**NOTICE OF ADDENDUM**  
**ADDENDUM NO. 3**

**CONTRACT NO. 7951**  
**Capitol East District Parking Structure**

This addendum is issued to modify, explain or correct the original Drawings, Specifications, or Contract Documents of the subject contract and is hereby made a part of the contract documents.

1A FLOOR PLAN - FIRST LEVEL  
1/8\"/>

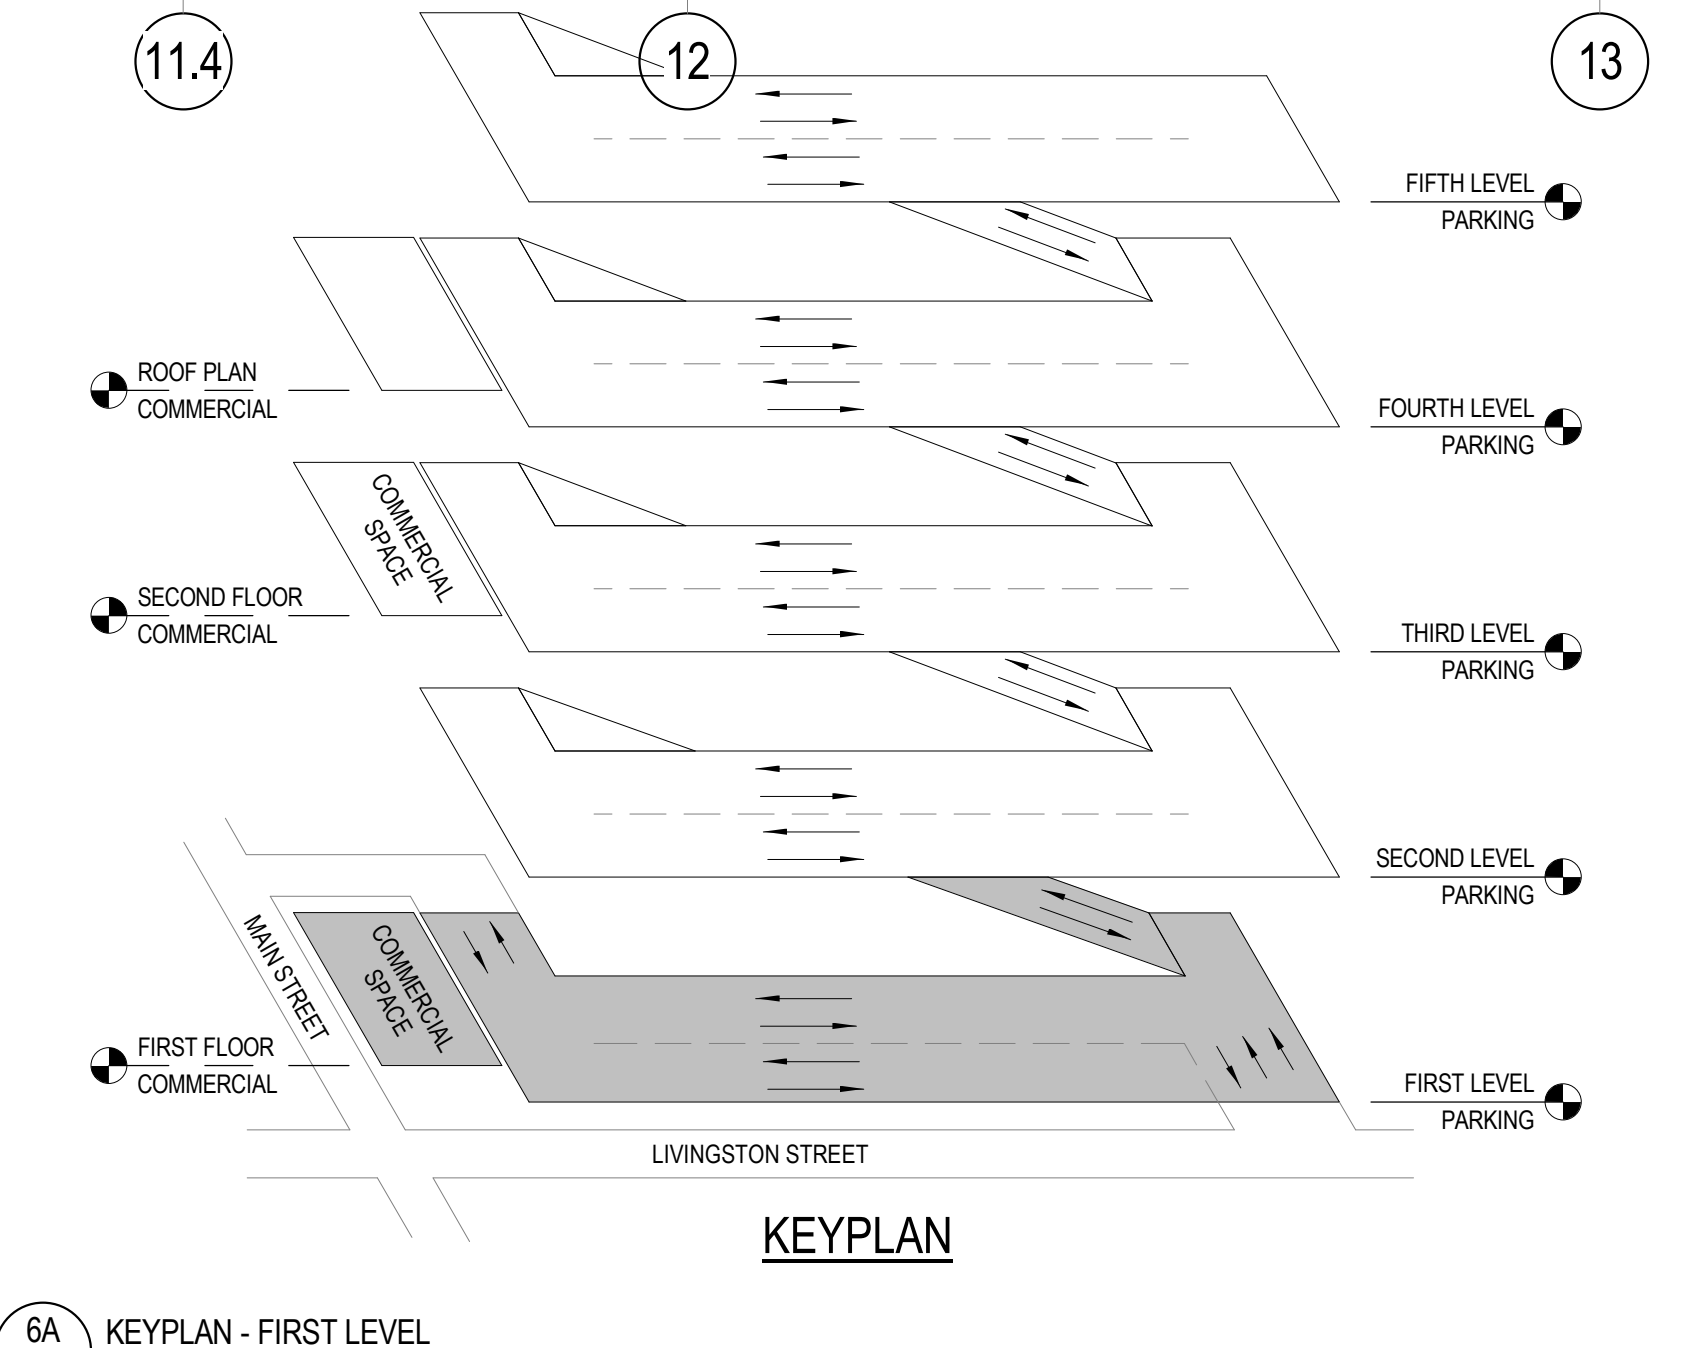
Q46: Floor and Finish Plan Keyed Note FL12 on A-101 indicates expansion joint & cover at the wall to wall joints in plan. 079513.2.2.B does not list a cover for the expansion joint. If a cover is required, please list the product to be used.

- A. A-101 – FIRST LEVEL PARKING - FIRST FLOOR COMMERCIAL PLAN (Reissued)
  - ii. Revise as noted on reissued sheet.
- B. A-102 – SECOND LEVEL PARKING PLAN (Reissued)
  - iii. Revise as noted on reissued sheet.
- C. A-103 – THIRD LEVEL PARKING - SECOND FLOOR COMMERCIAL PLAN (Reissued)
  - iv. Revise as noted on reissued sheet.
- D. A-104 – FOURTH LEVEL PARKING - COMMERCIAL ROOF PLAN (Reissued)
  - v. Revise as noted on reissued sheet.
- E. A-105 – FIFTH LEVEL PARKING PLAN (Reissued)
  - vi. Revise as noted on reissued sheet.
- F. A-543 – WALL SECTIONS & DETAILS (Reissued)
  - i. Revise as noted on reissued sheet.

1A FLOOR PLAN - SECOND LEVEL  
A-102 1/8" = 1'-0"

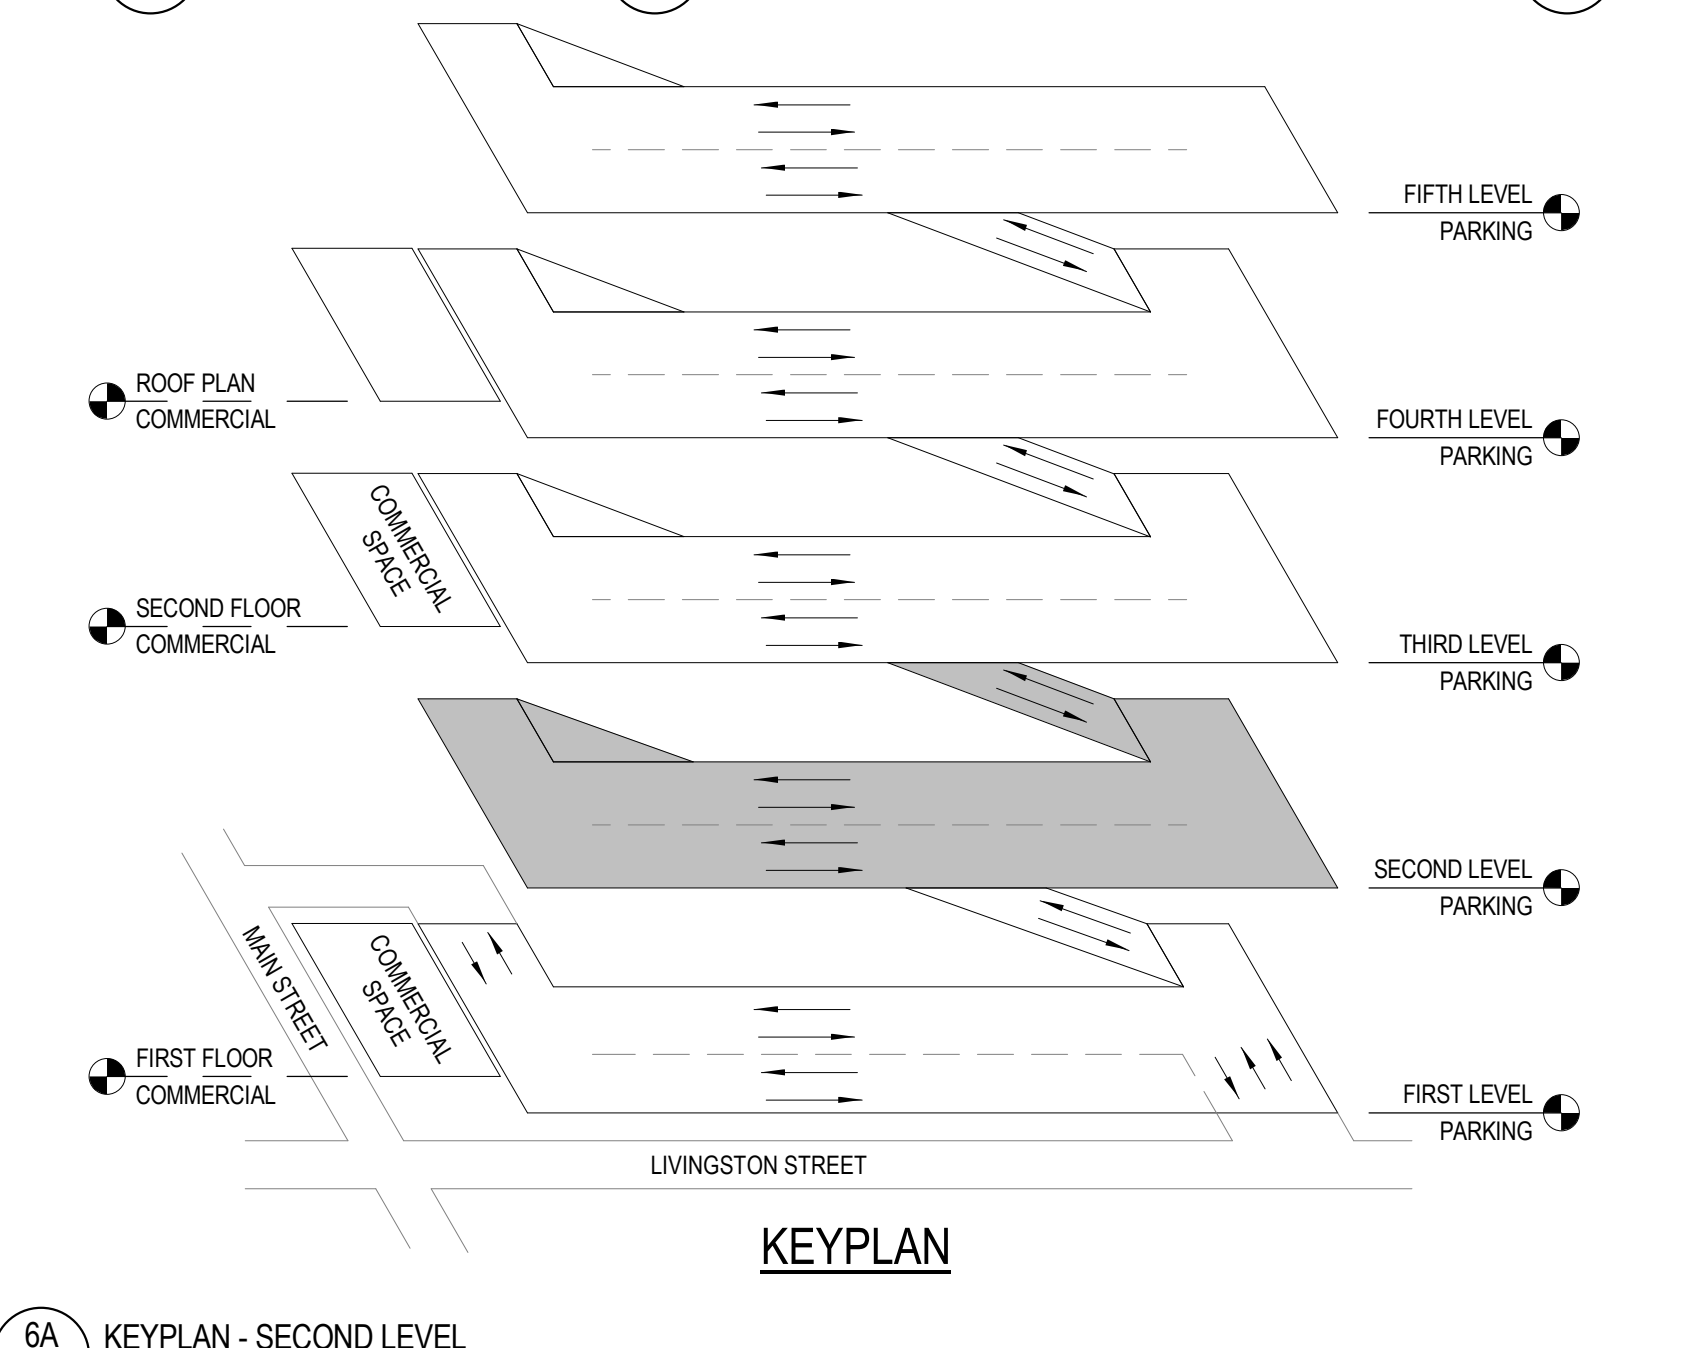
Q52: There is a note FL 12 Expansion Joint and Cover shown at lines 2+ 3 on the upper floors starting on drawing A102. This is between two walls. I don't see where an expansion joint cover would be installed.

**A52: Outdated notes on floor plans removed in AD-03.**

1 LANDSCAPE PLAN  
L-100  
3/29/2017 12:16:32 PM

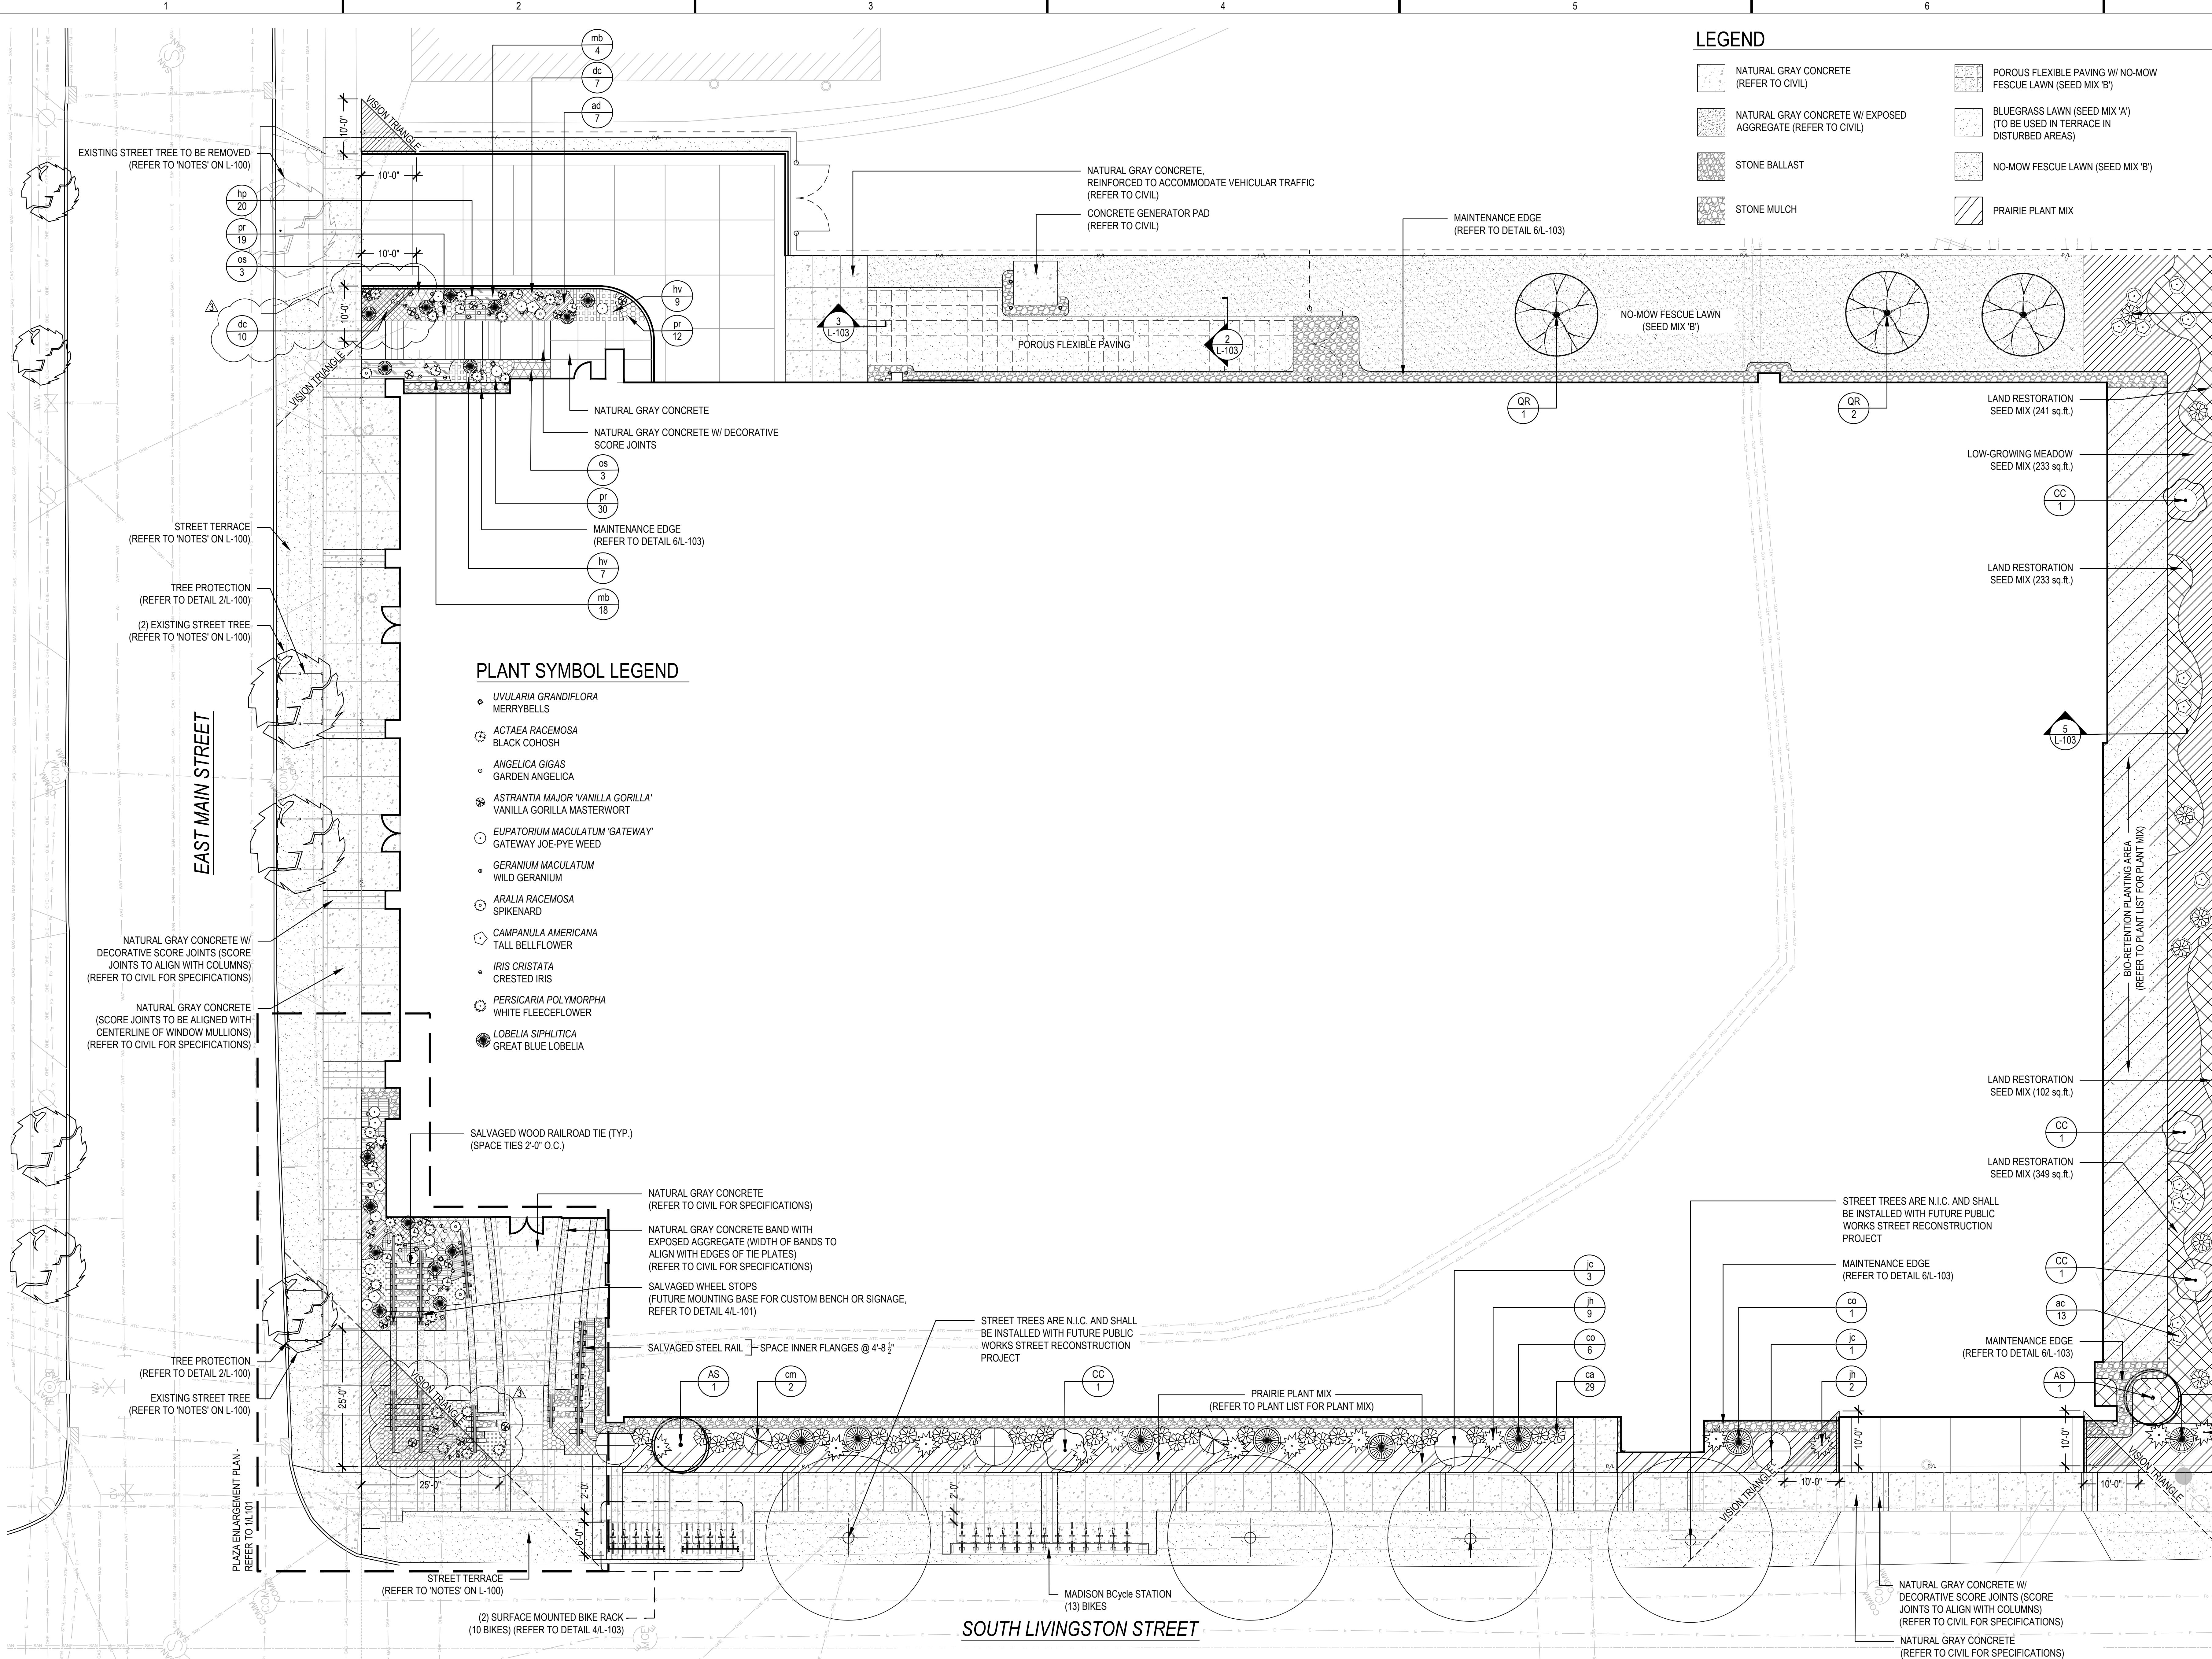
- A. L-100 – Landscape Plan (Reissued)
  - ii. Plant material taller than 30" was removed from within the vision triangles. See attached sheet for updated plant substitutions and quantities. The 'Tree Planting' detail was revised to call out shredded hardwood bark mulch.
- B. L-101 – Plaza Enlargement / Plant List & Landscape Calculations (Reissued)
  - iii. Plant material taller than 30" was removed from within the vision triangle. See attached sheet and plant list for updated substitutions and quantities.
- C. L-102 – Layout Plan (Reissued)
  - i. Dimensions were updated to reflect the hardscape revisions due to the bicycle racks moving. See attached sheet.
